Operator NEW Enterprise
 Well Weller Federal #2
 Unit L Section 23 Township 7 Range 26
 API # 30-005-61319

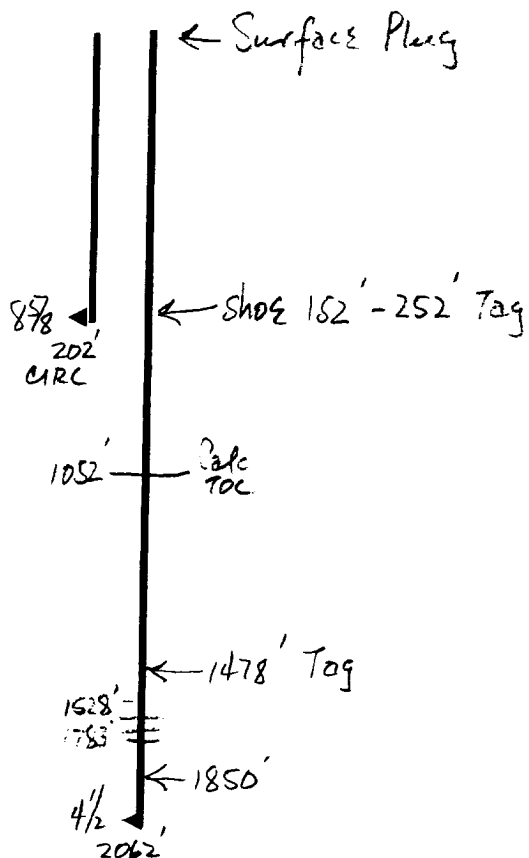
- * Contact OCD 24 hrs. prior to any work done.
- * Salt gel mud consisting of 10# brine with 25# of gel per barrel must be placed between each plug.
- * Install dry hole marker as per Rule 202.B.2
- * Plugs are to be set from point indicated up.
- * Plugs must not be less than 100' or 25 Sacks of cement, whichever is greater, unless specifically indicated.
- * Shoe and stub plugs will be 50' above and below shoe or stub and tagged.
- * Surface plug will be from 0' - 60'
- * Where plugs are required, cement must be placed inside and outside of **all** casing string(s) in the correct footage or sacks required, **if no cement exists.**
- * Plugs to be tagged will be indicated.
